Planning Application 253071

Submitted by: **Fernanda Rossatto**

Address: 23 Canberra Lake Way, Charvil, RG10 9DH

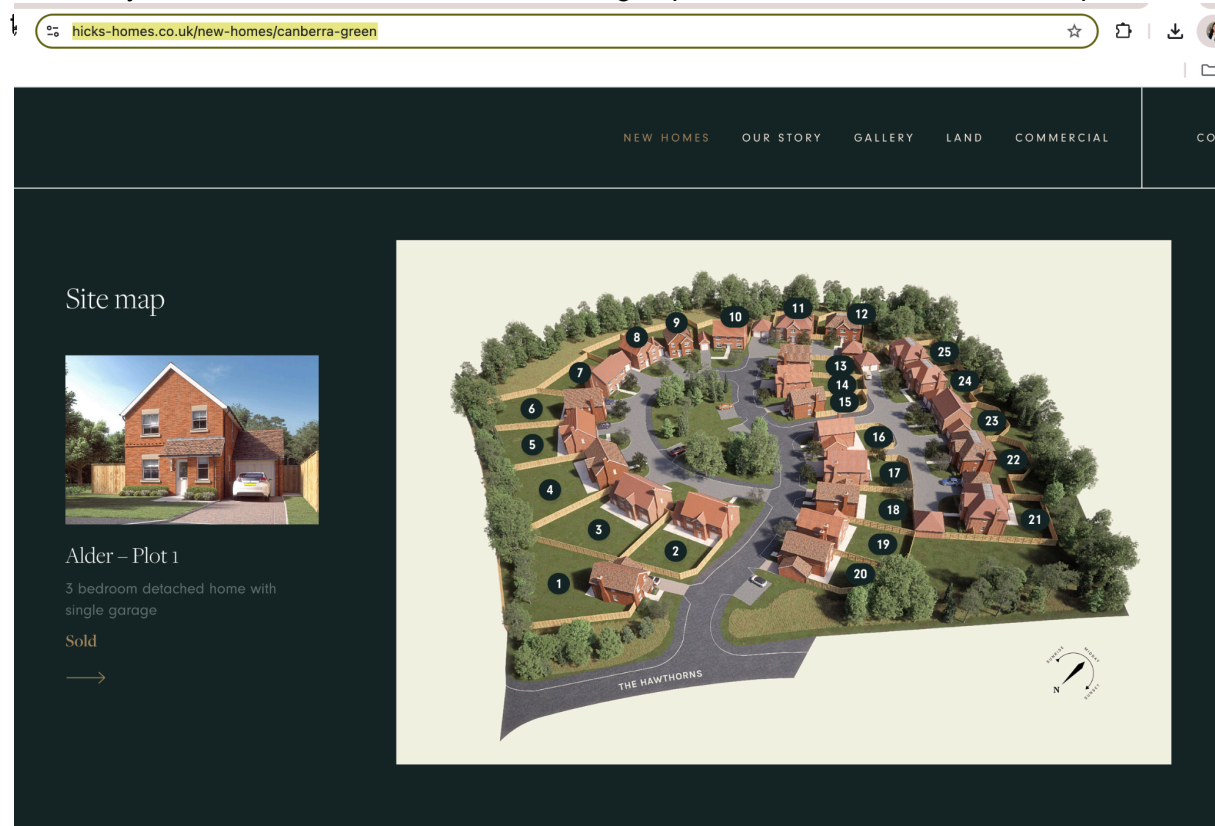
My primary concern is the token buffer proposed between the new development and the existing Canberra Lake Way development.

The published plans and marketing material for Canberra Green consistently showed a significant belt of trees behind the properties on Canberra Lake Way. This remains visible on the [Hicks Homes website](https://hicks-homes.co.uk/new-homes/canberra-green). Until Bellway submitted its detailed proposals, residents therefore had every reason to understand that a meaningful planted buffer of trees would separate the

The currently proposed separation does not amount to a continuous, robust and effective landscape buffer. In particular, a strip of approximately three metres beyond the existing property boundaries is unlikely to provide sufficient space for substantial trees and understorey planting to establish and thrive. It also leaves little resilience if individual trees fail.

Private rear gardens within the proposed development appear to extend directly towards the Canberra Lake Way boundary. This is notably different from the treatment of The Hawthorns, where a landscape strip has at least been provided, although I also consider the screening there insufficient.

1. A substantially wider, continuous and ecologically functional landscape buffer along the Canberra Lake Way boundary.
2. A detailed planting schedule specifying species, planting sizes and anticipated maturity.
3. Early implementation of the boundary planting.
4. An enforceable long term landscape and ecological management plan.
5. **Meaningful recreational provision for older children and teenagers, ideally through a pump track or a contribution towards one elsewhere in Charvil.**
